**Maine Maritime Academy
Castine, Maine**

**Pier Upgrades and Waterfront Improvements Project
April 5, 2024
ADDENDUM NO. 10**

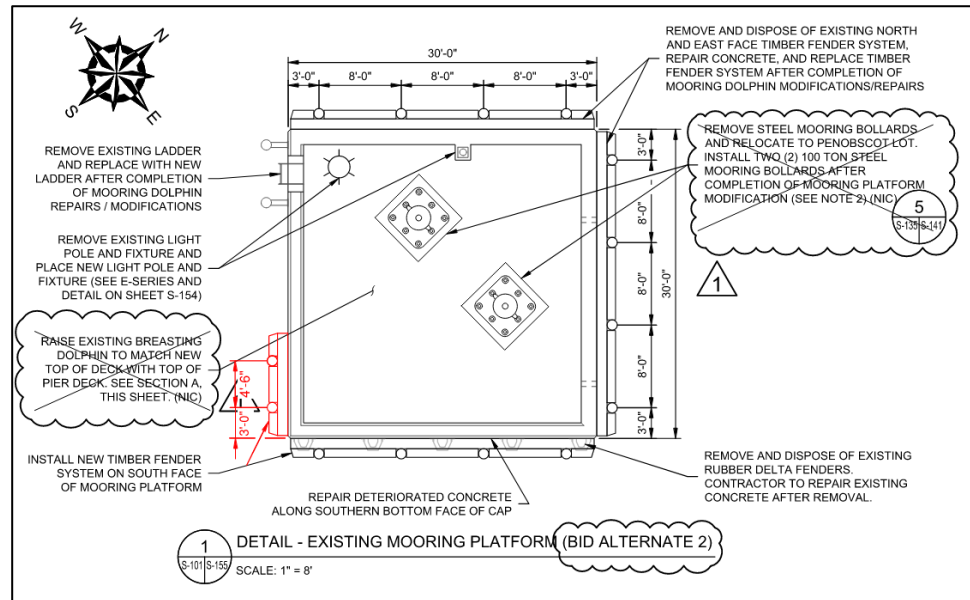
1. IFB Drawing S-113: Please clarify quantity and layout of timber fender piles on the existing breasting and mooring platforms. Layout drawing S-113 does not align with drawing S-155.

Response 1: **ADD** 2 timber fender piles to the south face of the Existing Mooring Platform in Detail 1 on Drawing S-155.

Excerpt of Section A

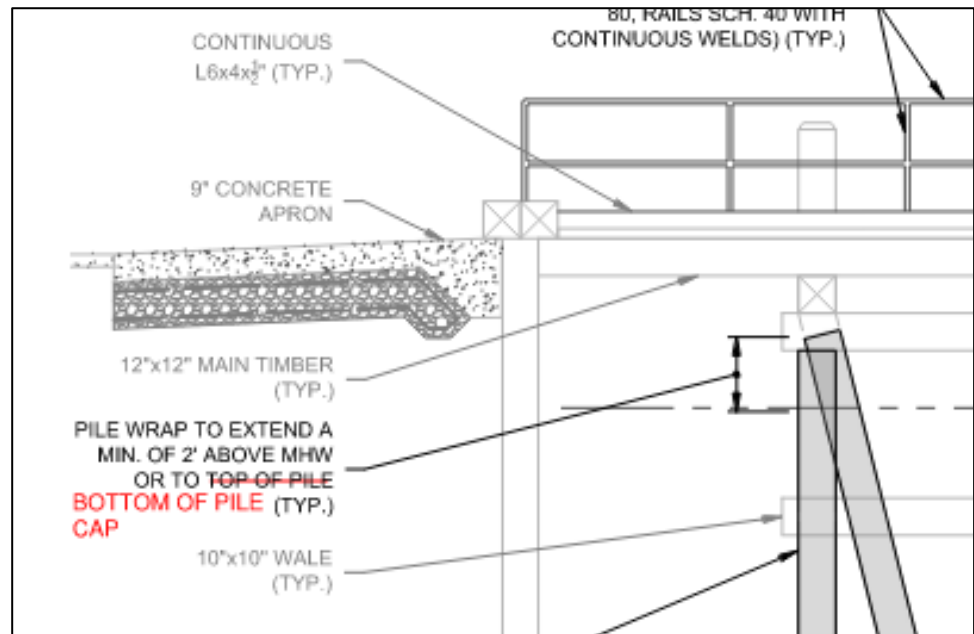
17. IFB S-177: Travel Lift S-177 Plans require wraps to extend a minimum of 2' above MHW. Is spacing between MHW and 12"x12" timber pile cap adequate to allow this. If not would wrapping up to the cap be acceptable?

Response 17: In Section A and Section B, in the pile wrap callout, **REPLACE** "top of pile" with "bottom of pile cap".
